11 September 2018
Our Ref: 20550A.2ER_Submission

**Submission in relation to SSD 17_8876
Sydney Metro Pitt Street (South) Over Station Development**

Figure 1 Aerial photograph of Princeton Apartments building in relation to Lot 1 DP62668

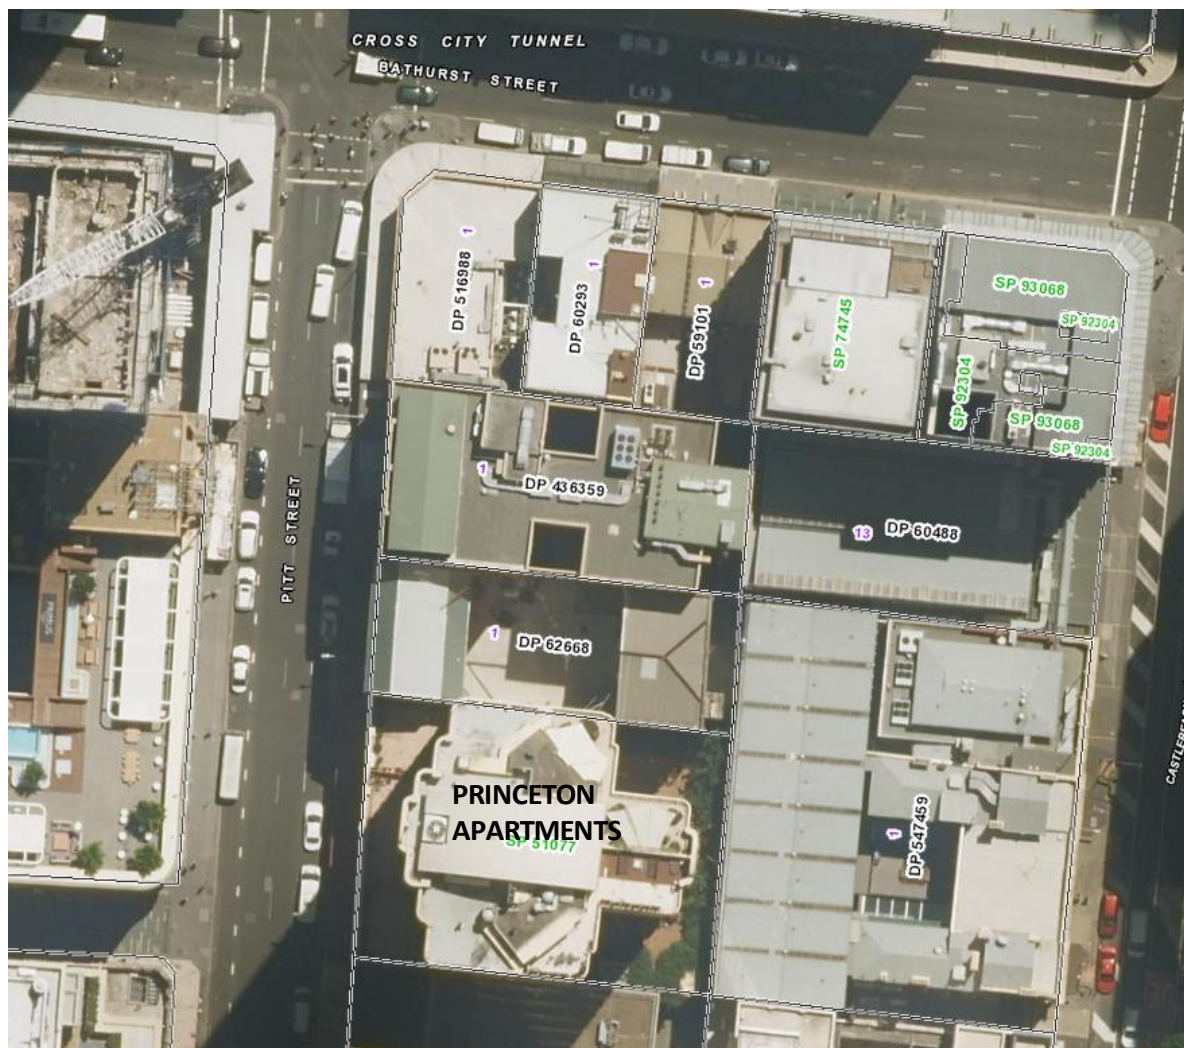
Princeton Apartments is an approved development which is built to the northern boundary of the lot on which Princeton Apartments is located – see **Figure 1** below.

The plans submitted in relation to the concept scheme application propose a setback of 3m from the northern boundary of the Princeton Apartments site up to a height of RL71. Above RL71 the concept plans show a setback of 12m to the northern boundary of the Princeton Apartments site.
